ADDENDUM #04

Greene County Visitor Center Project
705 Main Street, County Road 23B, Leeds, N.Y. 12451
Kaaterskill Associates Project No.: 84517.06

Addendum 04 Issue Date: May 29, 2024

EJN

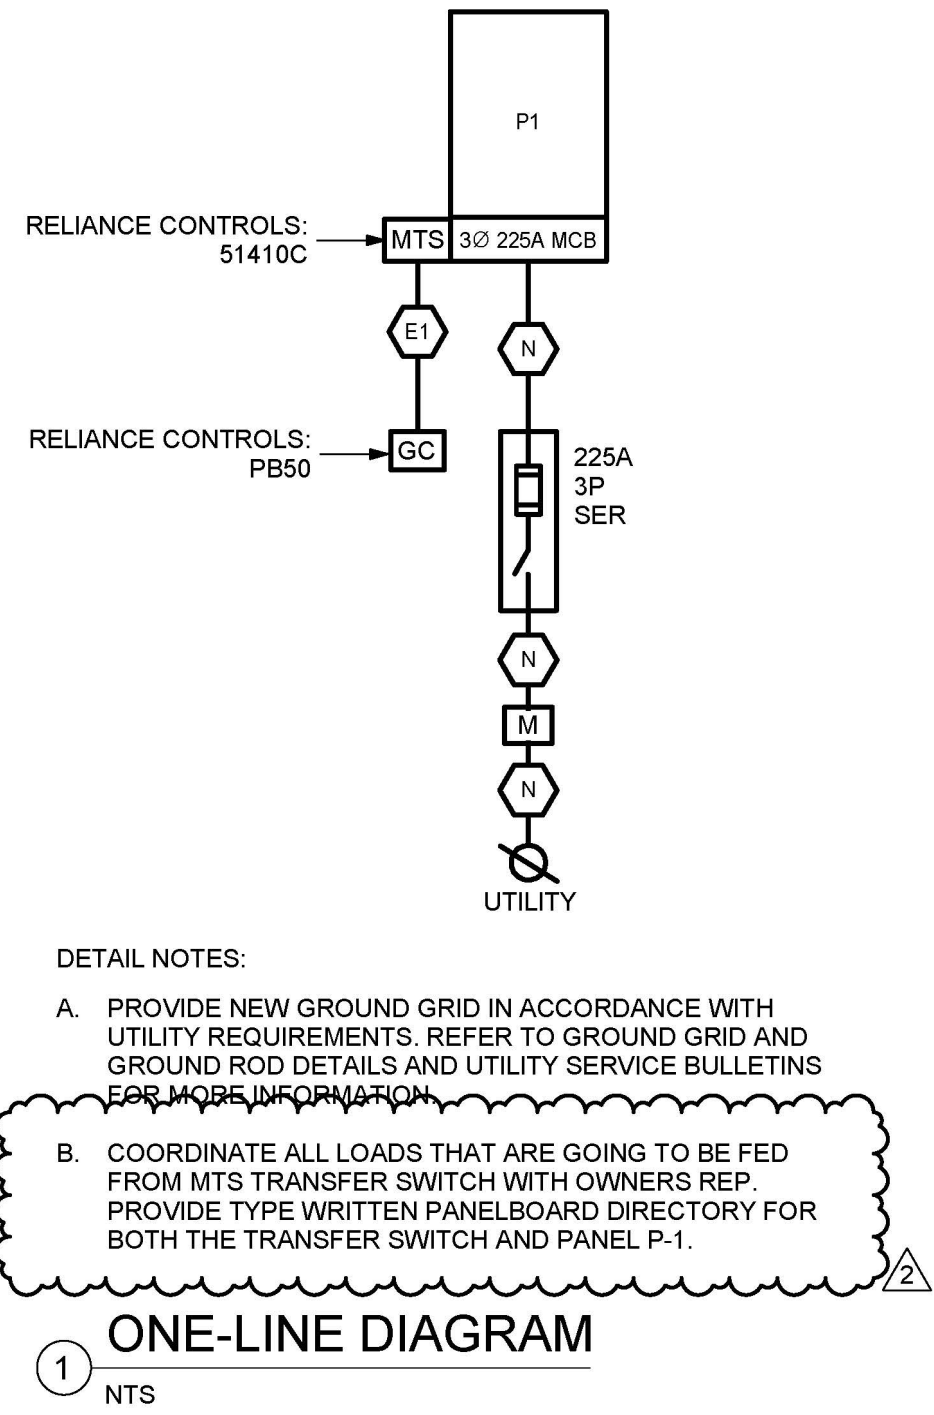
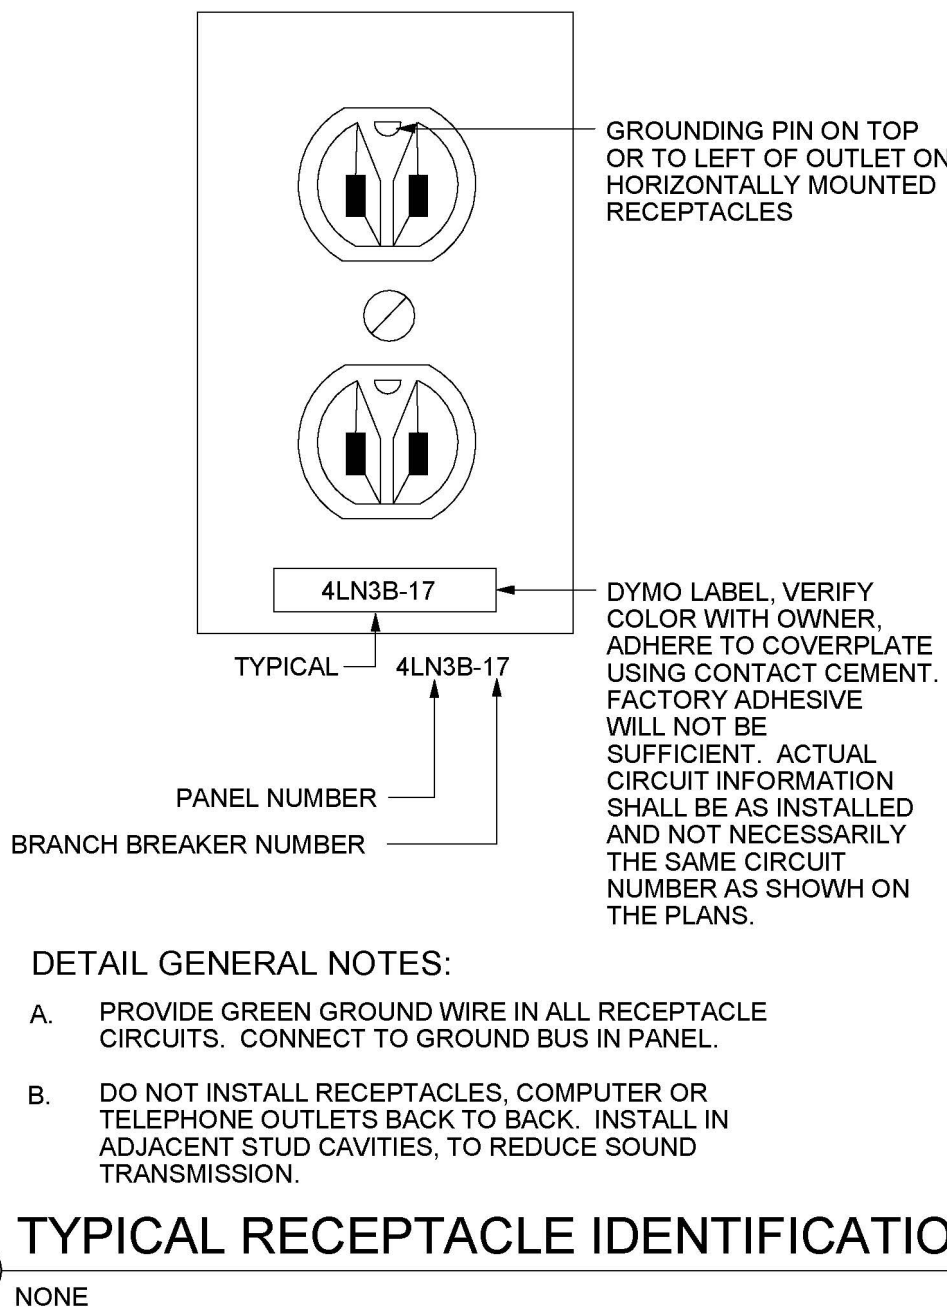
<u>Sheet/Detail</u>	<u>Description</u>
E-3	Added to current Bid Set: (see revision clouds)
E-6	Added to current Bid Set: (see revision clouds)
E-7	Added to current Bid Set: (see revision clouds)

A031: Refer to revised Electrical drawings E-1 through E-7, revision date 05/28/24.
